RE: **PROJECT NO. 173120 T.O. 21 FEMA FLOOD DAMAGE  
PROJECTS 115010, 116205, 117880, 126333, 126335, 126336**

### **ADDENDUM NO. 5**

**ADDENDUM NO. 5  
TO  
FEMA FLOOD DAMAGE PROJECT  
PROJECTS NO. [115010, 116205, 117860, 126333, 126335, 126336]**

ZINK PARK - SITE 4

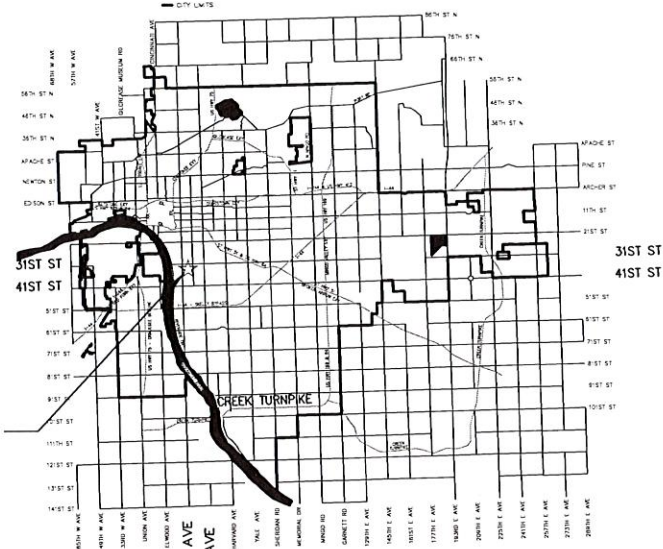
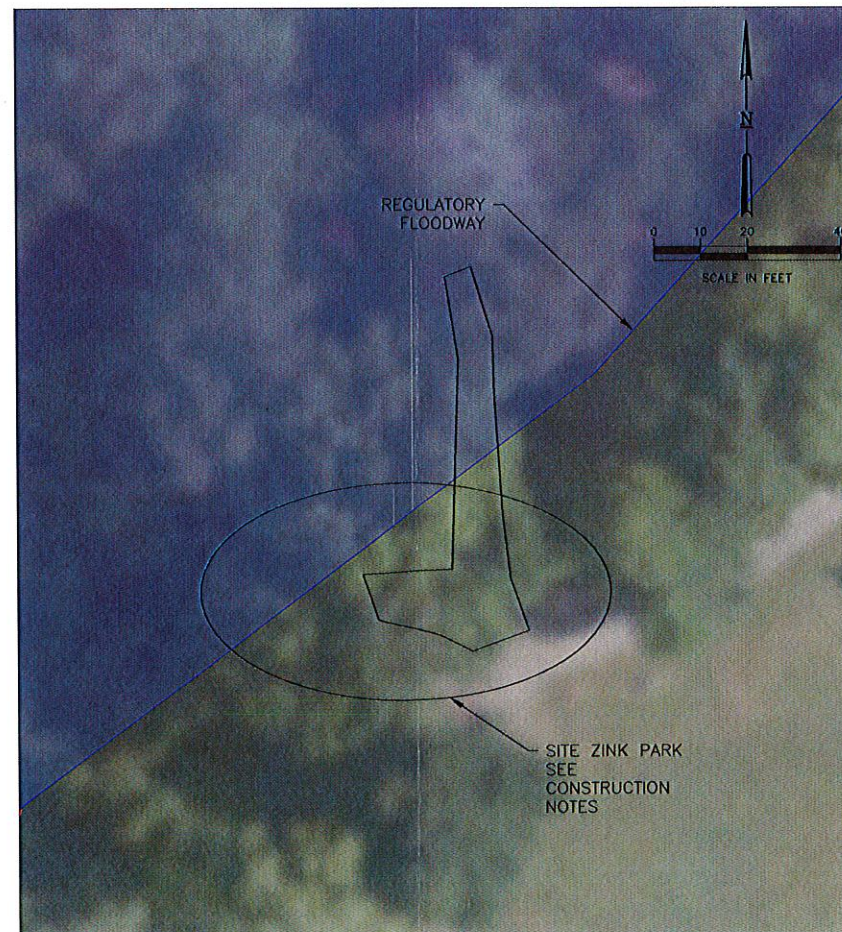
1. Updated electronic bid proposal form to include 120 calendar days to completely construct and finish all the work due to added complexity and additional pay items for Non-Participating portion of the project.
2. Updated Sheet 2 – GENERAL CONSTRUCTION NOTES & PAY ITEMS to include additional pay items and pay item notes for Non-Participating portion of the project.
3. Updated Sheet 12 – FEMA SITE ZINK PARK – SITE 4 to include additional pay items for Non-Participating portion of the project.

| DI# 331403 - ZINK PARK - SITE 4 |      |   |                  |      |          |
|---------------------------------|------|---|------------------|------|----------|
| NON-PARTICIPATING               |      |   |                  |      |          |
| 611(A)                          | 2657 | MANHOLE (4' DIA.), COMPLETE IN PLACE                            | D-1,2,3,4,5      | EA   | 3.00     |
| 611(B)                          | 2680 | ADD'L DEPTH IN MANHOLE (VF)                                     | D-4              | VF   | 18.00    |
| 611(G)                          |      | INLET, SDI TYPE 2 W/ BAR GRATE, COMPLETE IN PLACE               | D-1,2,3,7,8,9,10 | EA   | 3.00     |
| COT 215                         |      | (SP) 18" CORRUGATED POLYPROPYLENE PIPE (CPP), COMPLETE IN PLACE | D-13,14,15 S-19  | LF   | 48.00    |
| COT 215                         |      | (SP) 24" CORRUGATED POLYPROPYLENE PIPE (CPP), COMPLETE IN PLACE | D-13,14,15 S-19  | LF   | 122.00   |
| SPECIAL                         |      | OUTFALL STRUCTURE, COMPLETE IN PLACE                            |                  | EA   | 1.00     |
